# Final Drainage Report

## **Ellicott School Addition - 2 Buildings**

**Project No. 61183**

**PCD File No. PPR-22-50**

**PHASE II  
DRAINAGE MAP  
(PROPOSED)**

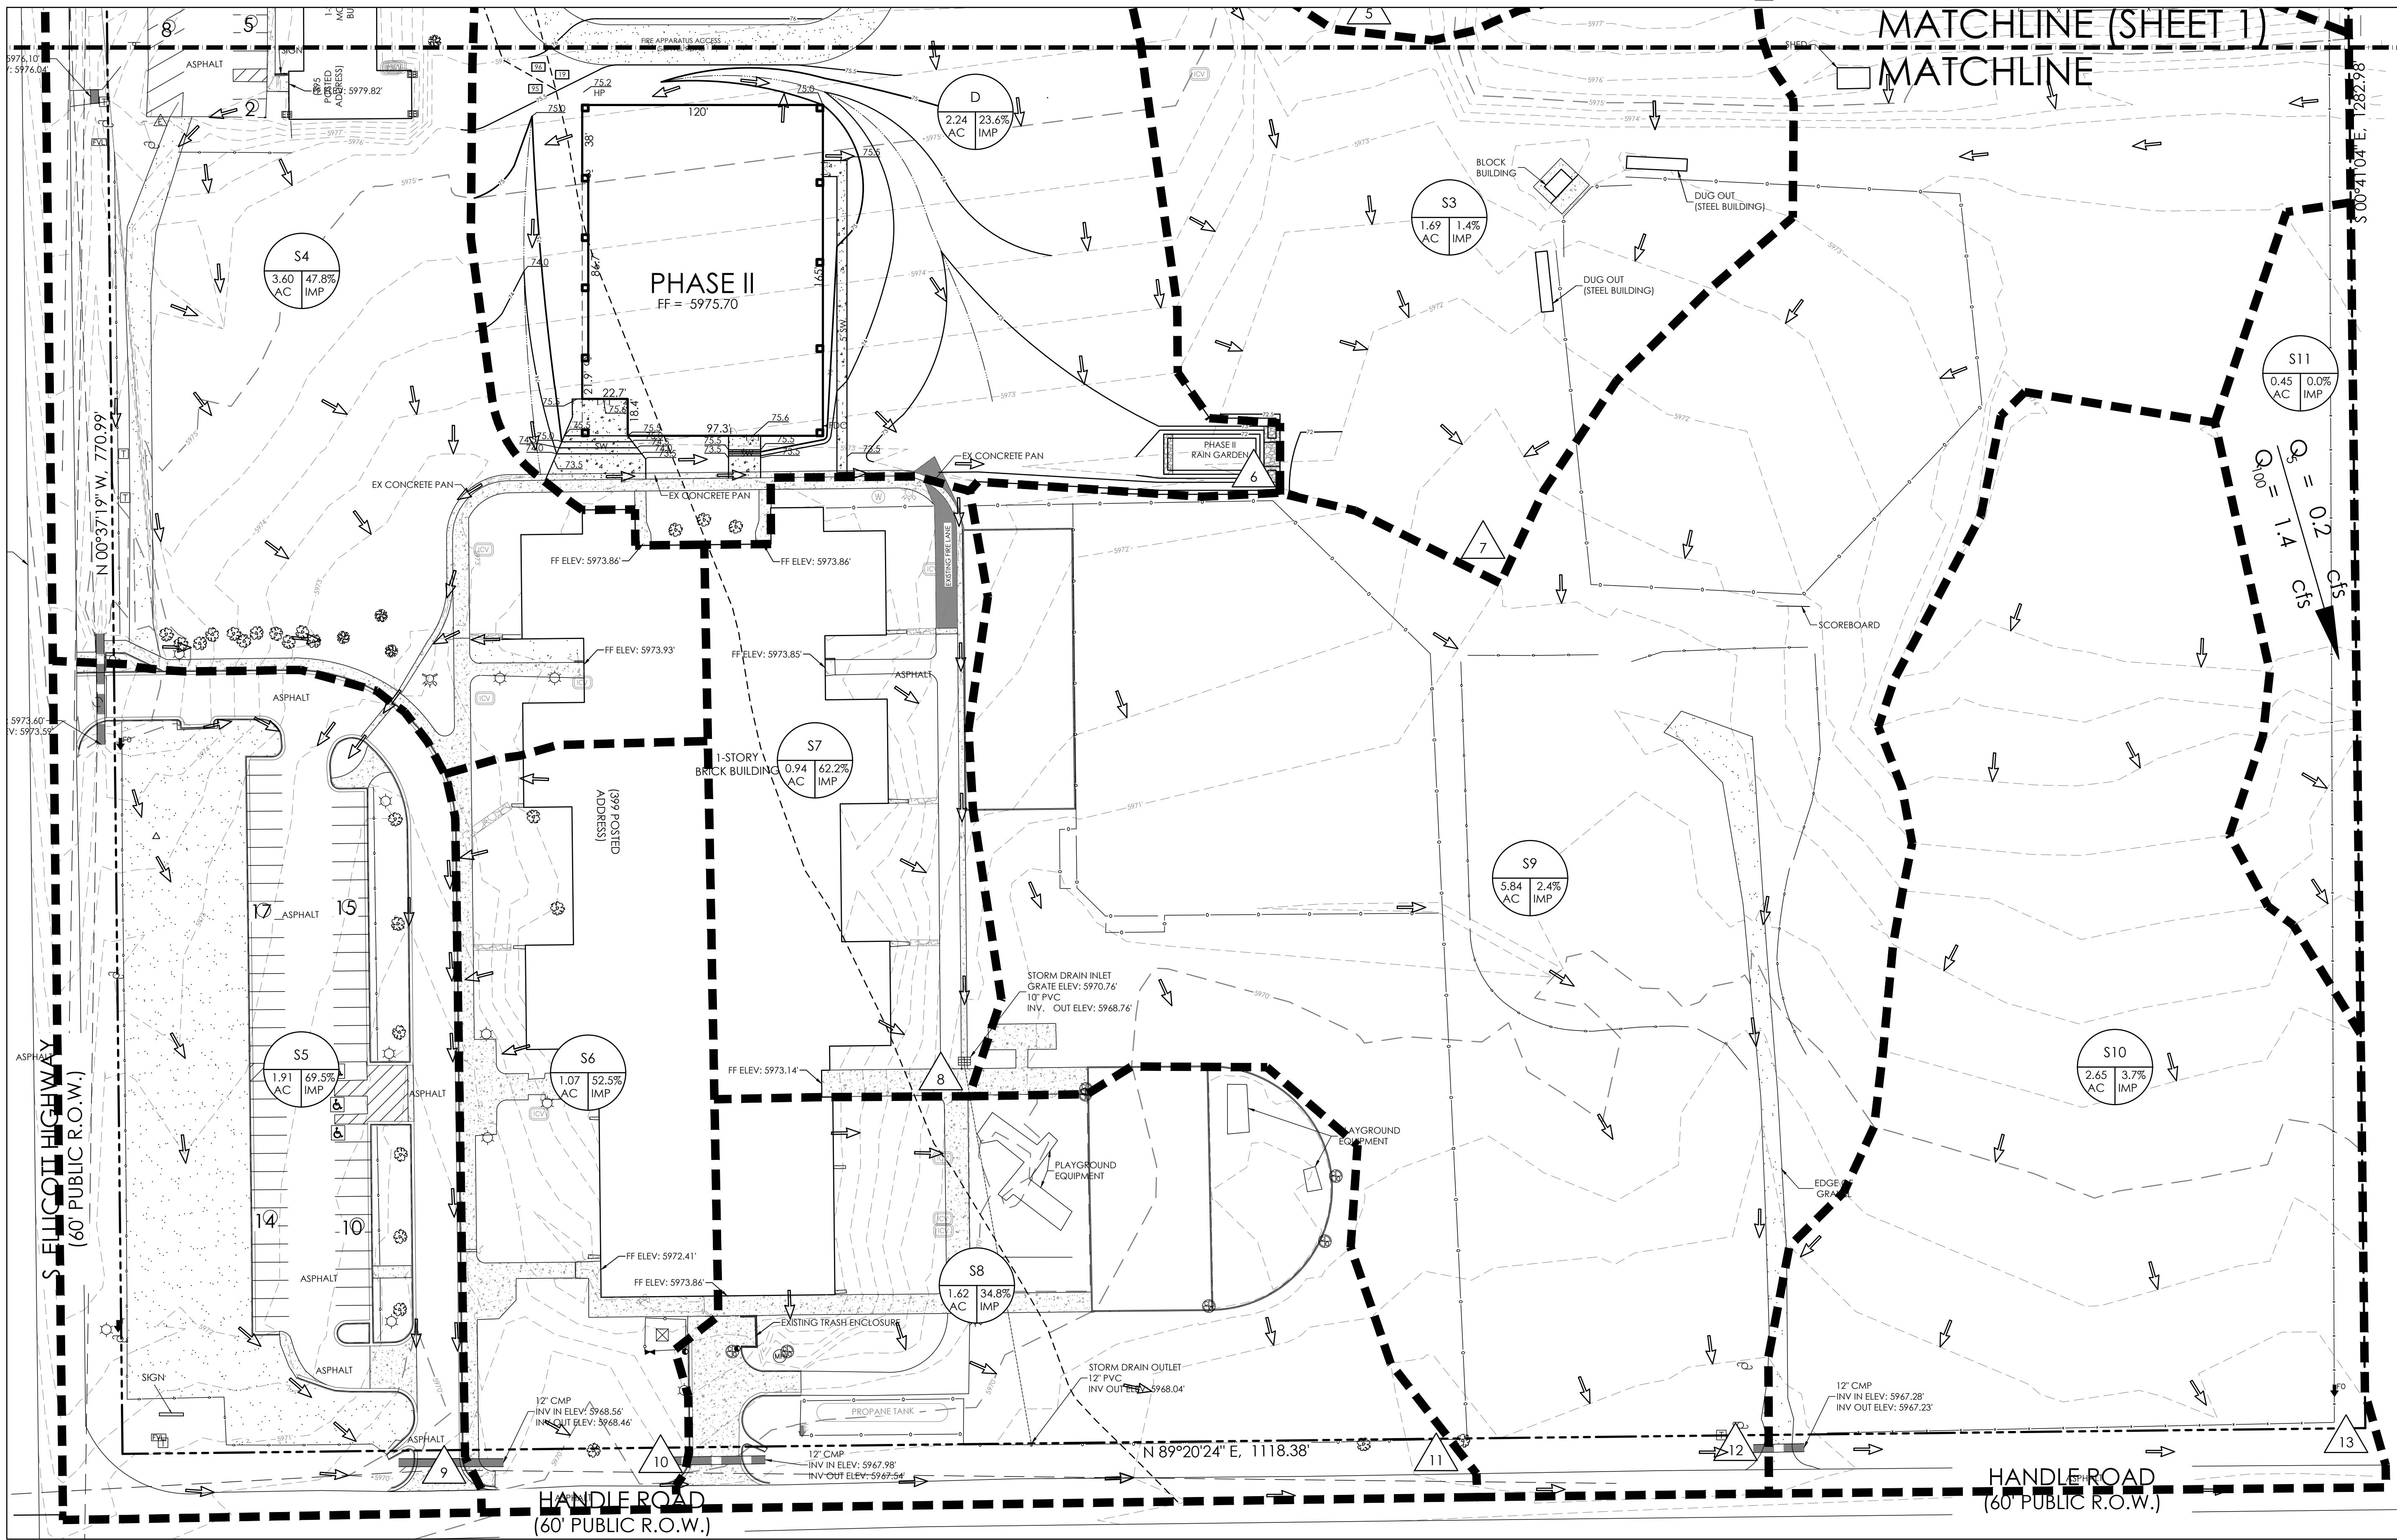
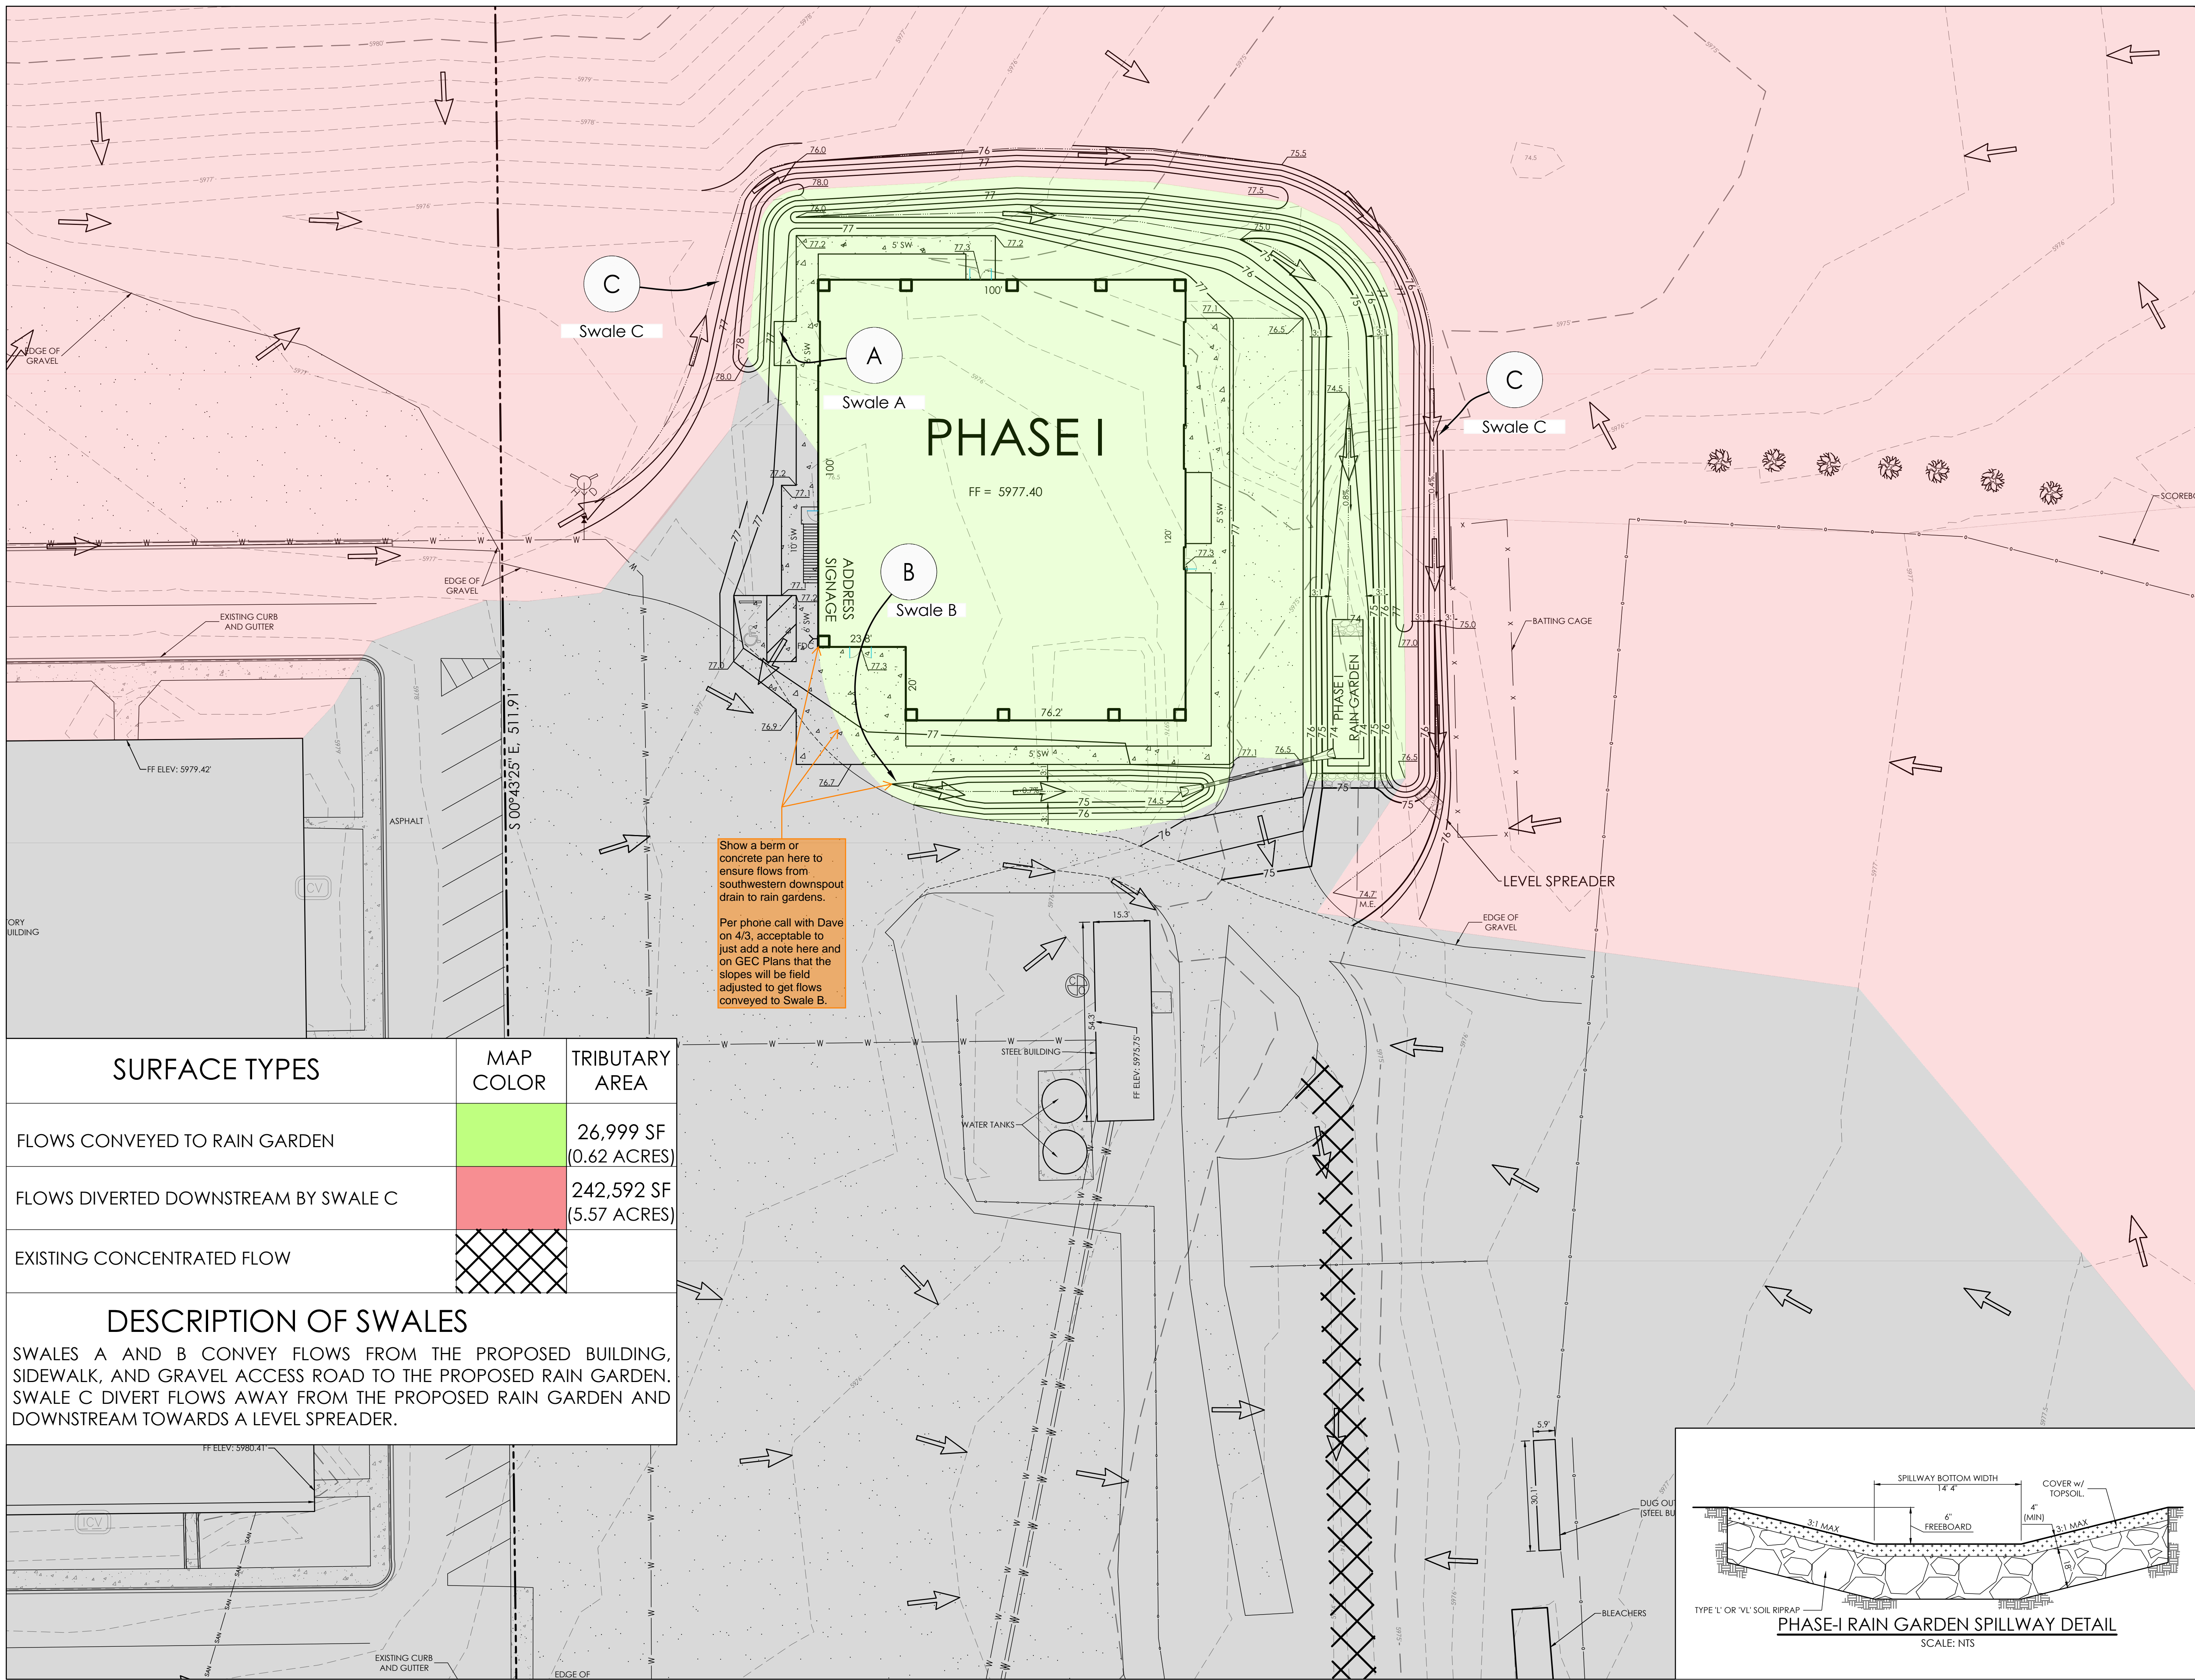
Show a berm or concrete pan here to ensure flows from southwestern downspout drain to rain gardens.

Per phone call with Dave on 4/3, acceptable to just add a note here and on GEC Plans that the slopes will be field adjusted to get flows conveyed to Swale B.
